WATER QUALITY MEMORANDUM Utah Coal Regulatory Program

SUBJECT: 2009 3rd Quarter Water Monitoring: REVISED REPORT, CW Mining Company, Bear Canyon Mine, C/015/0025, Task ID # 3373

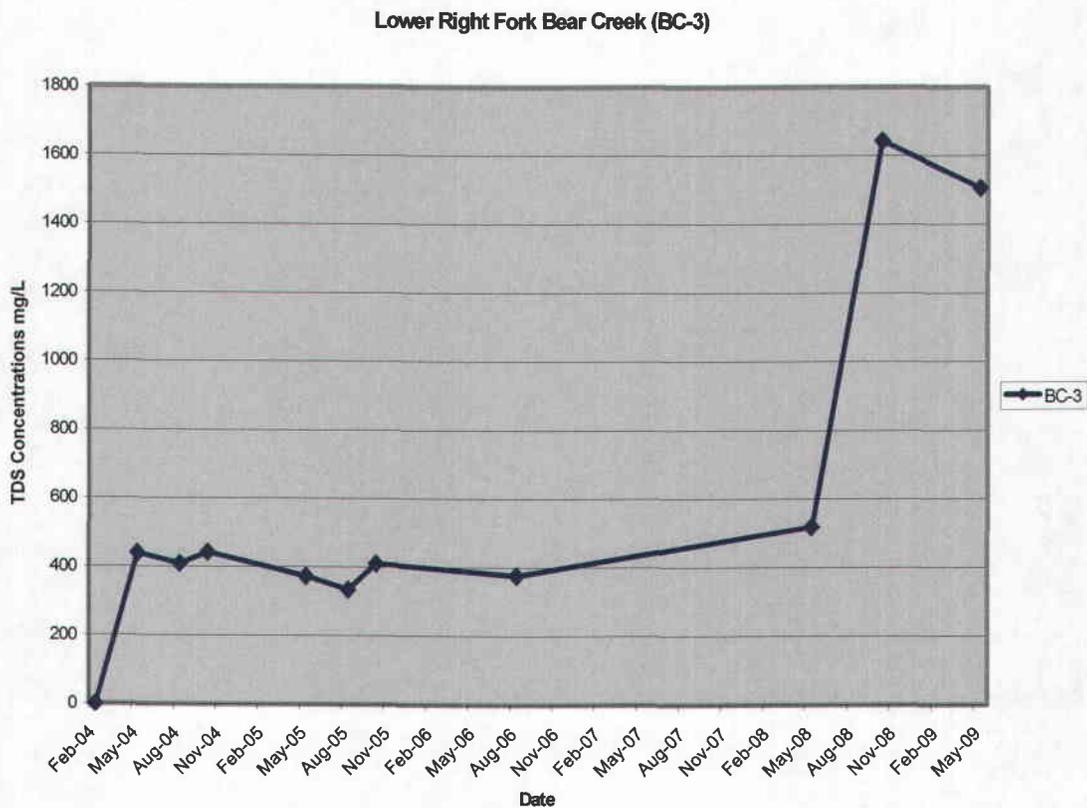
Sample BC-3 at the Lower Right Fork of Bear Creek has shown a recent increase in the levels of Total Dissolved Solids (TDS) since Fall 2008. Prior to this increase, TDS levels have averaged around 400 mg/L since 2004 (see chart below). This sample location was dry in August and September 2009 and therefore, a TDS data point could not be collected.

- Sample BC-3 at the Lower Right Fork of Bear Creek has shown a recent increase in the levels of Total Dissolved Solids (TDS) since Fall 2008. This indicates that excess sediment may be discharging into the creek. The operator should evaluate sediment controls in this area and determine if there is any mitigation needed to control the level of sediment entering the water body. The location of stream sample BC-3 is an important one due to the fact that it is located adjacent to the main road. A high likelihood of this area receiving sediment from the disturbed area exists. Therefore, the Division recommends that Permittee modify the water monitoring plan to sample this location for operational parameters whenever flow is present. Currently, the water monitoring plan only requires the location be sampled for operational parameters during the months of February, August, and October.
